Northern Natural Gas Company  
P.O. Box 3330  
Omaha NE 68103-0330  
402 398-7200

RE: Northern Natural Gas  
Northern Lights 2025 Expansion  
Docket No. CP24-60-000  
Variance Request – Additional Extra Temporary Workspace – Lake Mills to  
Albert Lea E-line Extension

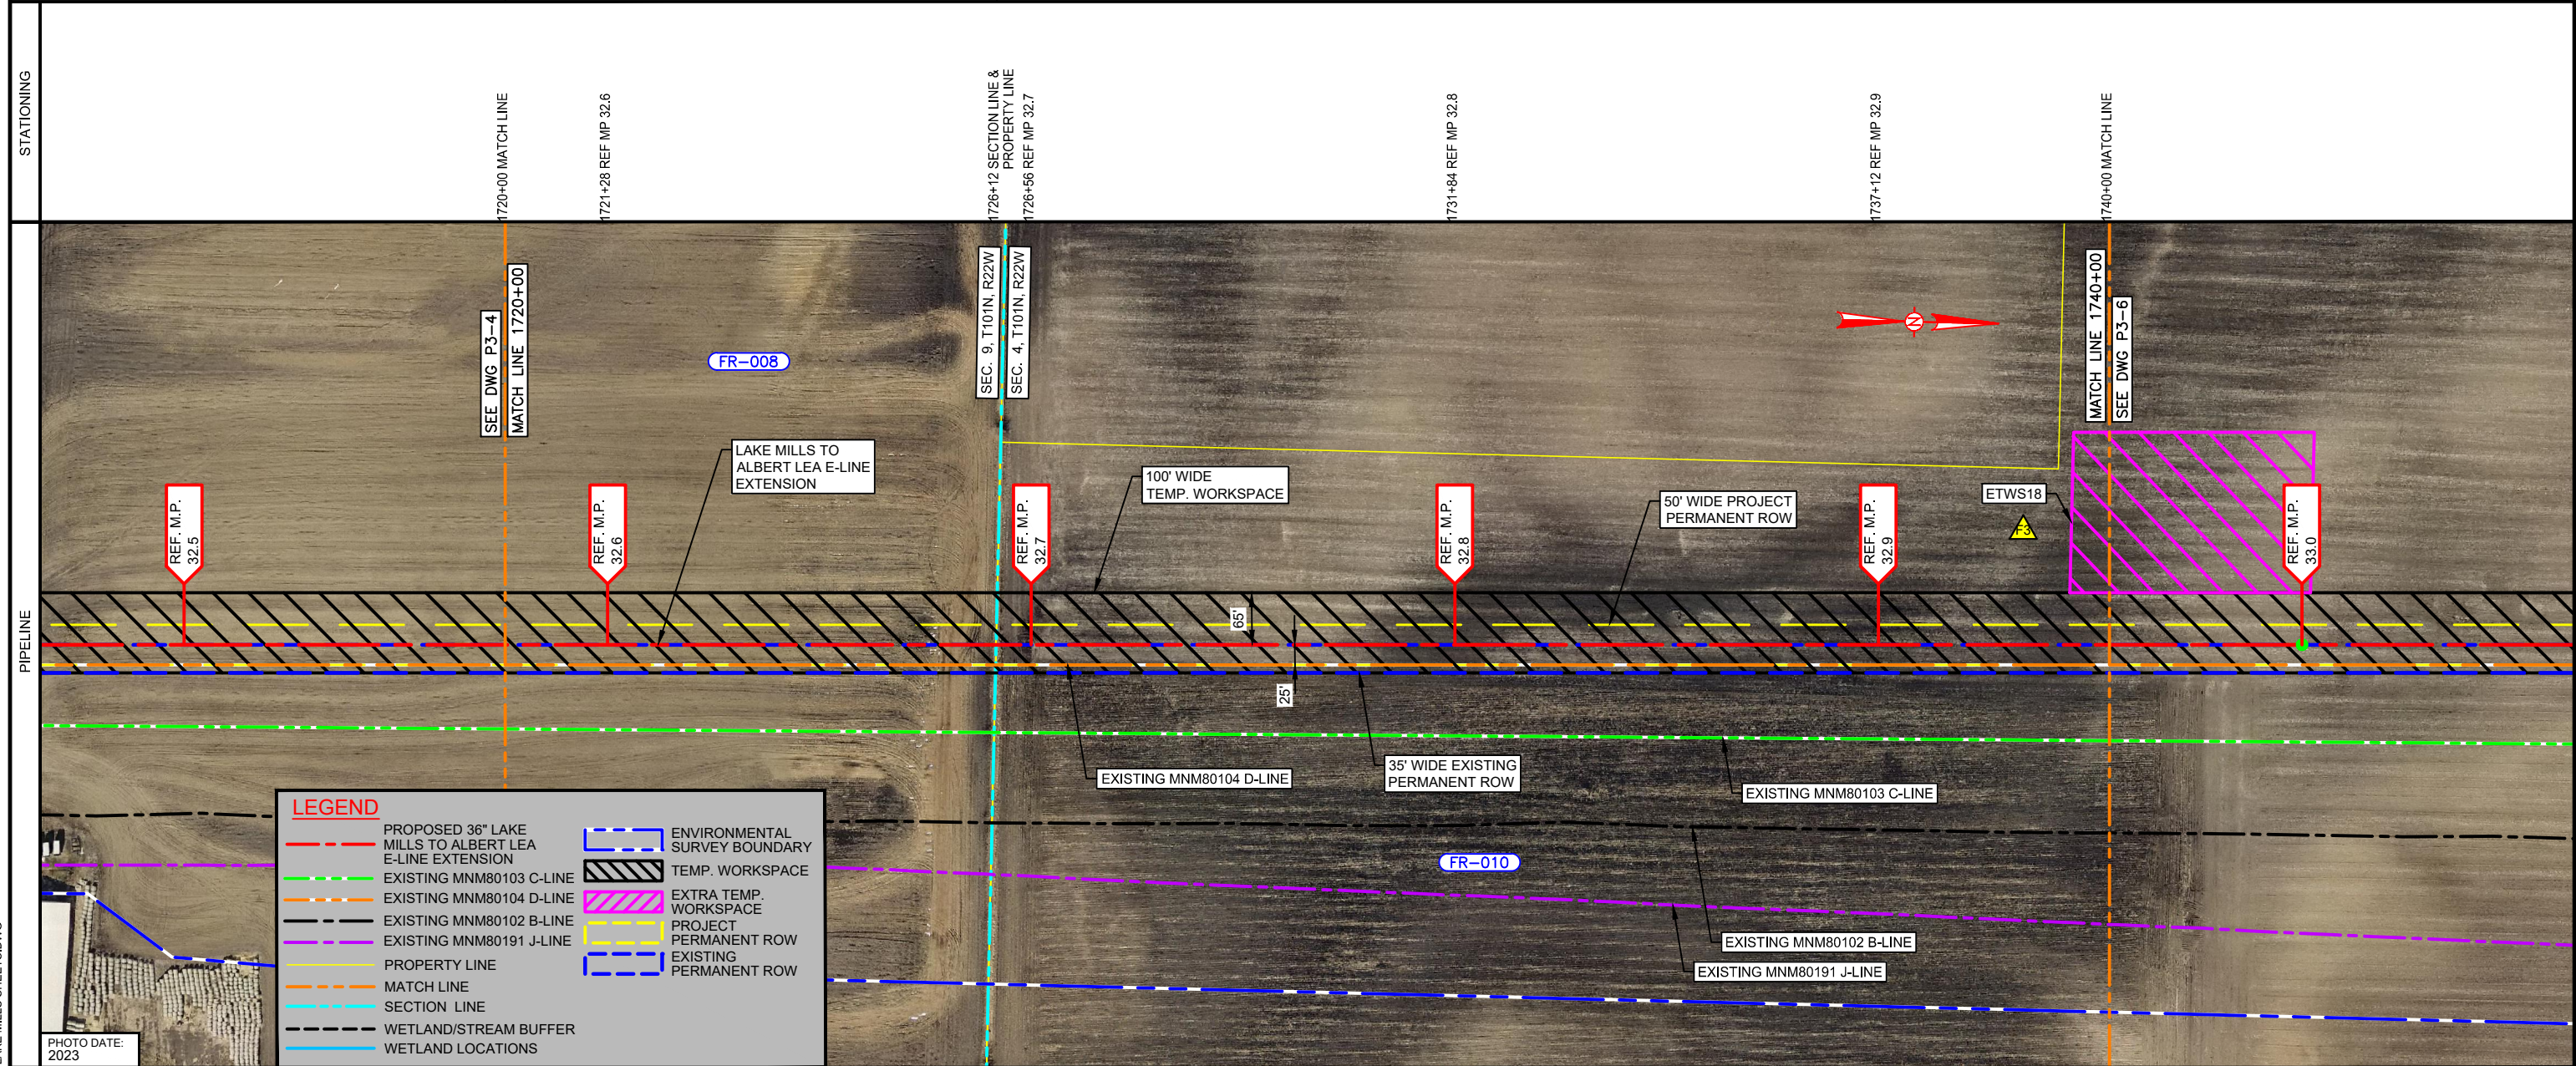
Proposed New ETWS	Mile Post/Alignment Sheet	Dimensions (feet)	Acreage	Tract Number
ETWS18	32.95 – 33.01 LML P3-5/P3-6	200 by 300	1.38	FR-010
ETWS19	32.19 – 32.46 LML P3-4	1400 by 125	4.00	FR-007

The proposed ETWS is being requested to accommodate the placement of topsoil and subsoil during open-cut trenching. Soil in the area is very saturated with several feet of standing water accumulating in low spots on the right of way. The soils exceed the liquid limit preventing cohesion of the soil particles necessary to pile the spoils as high as normal. This additional workspace is needed to allow for the wider soil storage piles.

The attached alignment sheets (public and privileged version) depict the proposed ETWS, which is highlighted with a Delta F3 symbol. The privileged alignment sheets contain confidential information regarding landowner names and have therefore been labeled “CUI//PRIV ---DO NOT RELEASE (PRIVILEGED).” Pursuant to 18 CFR Section 388.112, Northern requests confidential and privileged treatment of the privileged alignment sheets due to the confidential nature of the contents.
